Jeans Plus Ltd

Khalifa Apparels Ltd

Plot No-398, Sreepur Bus Stand, Ganakbari, Savar, Dhaka
(23.960985N 90.269380E)

13 May 2014

Heavy loading on slabs from finishes build-up in toilets, storage and water tanks

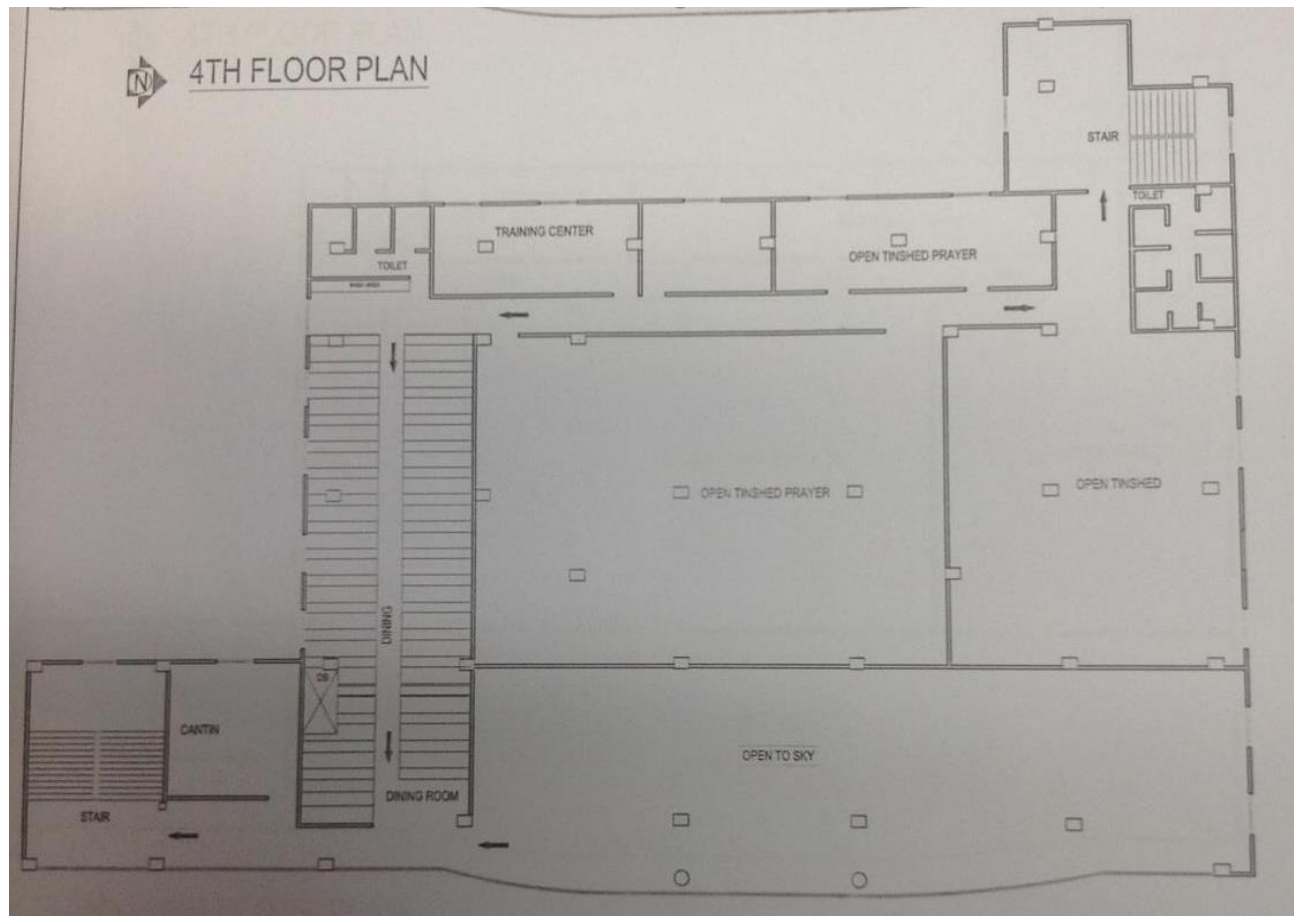
- Heavy slab loading was noted in (A) toilet areas (up to 420mm average build-up) and (B) on 2nd floor slab (about 4-5 kPa).
- We were also advised that there was up to 14,000 litres of water tanks on the roof to the stairs, but this could not be verified as there was no safe access.

Very irregular column layout

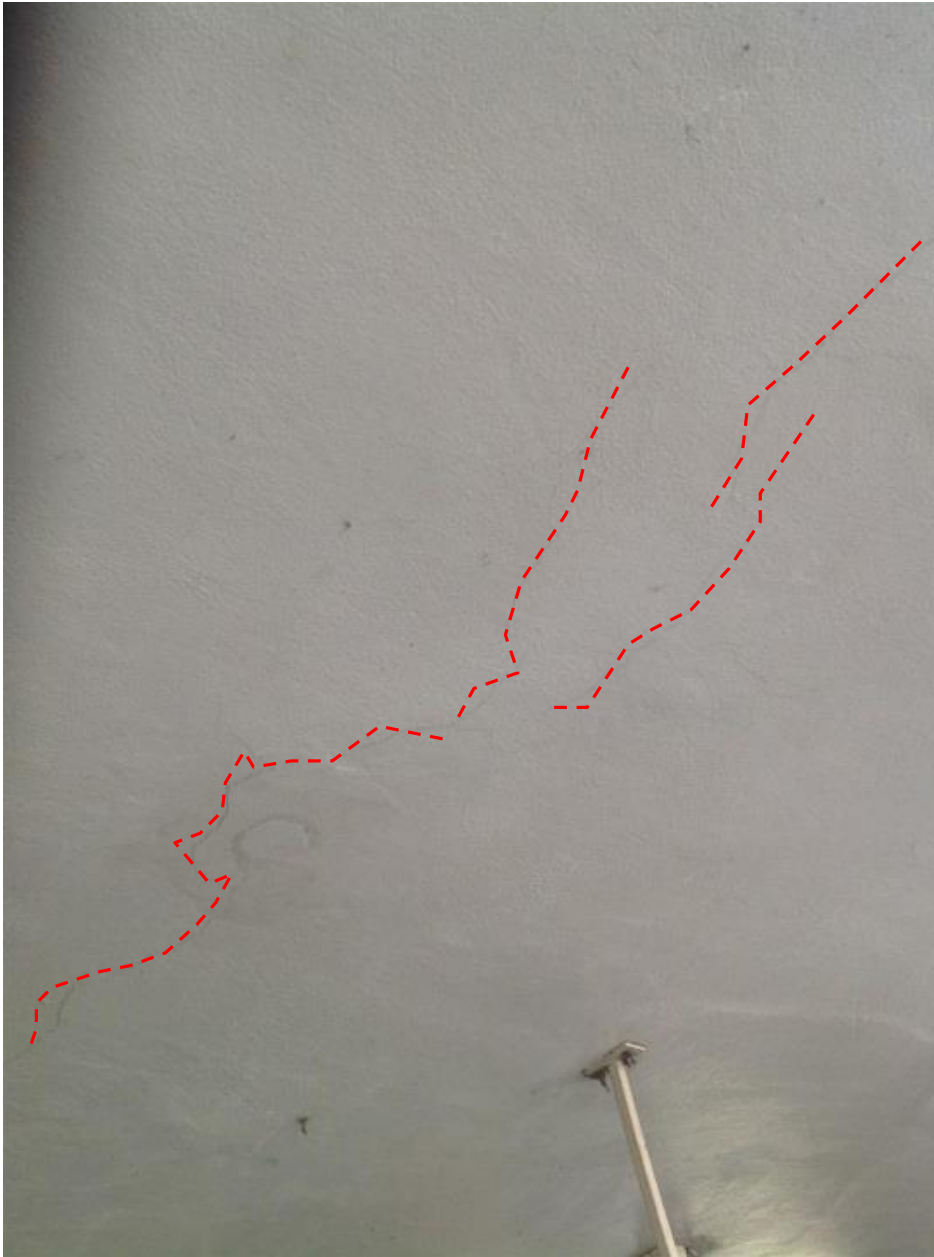
- The column layout is highly irregular and there is also a huge variation in column sizes.
- The column layout does not precisely match the drawings
- The drawings were signed 3 years after construction
- Only part of the building shown on the drawings has actually been built

This all suggests that the building may not have been properly engineered.
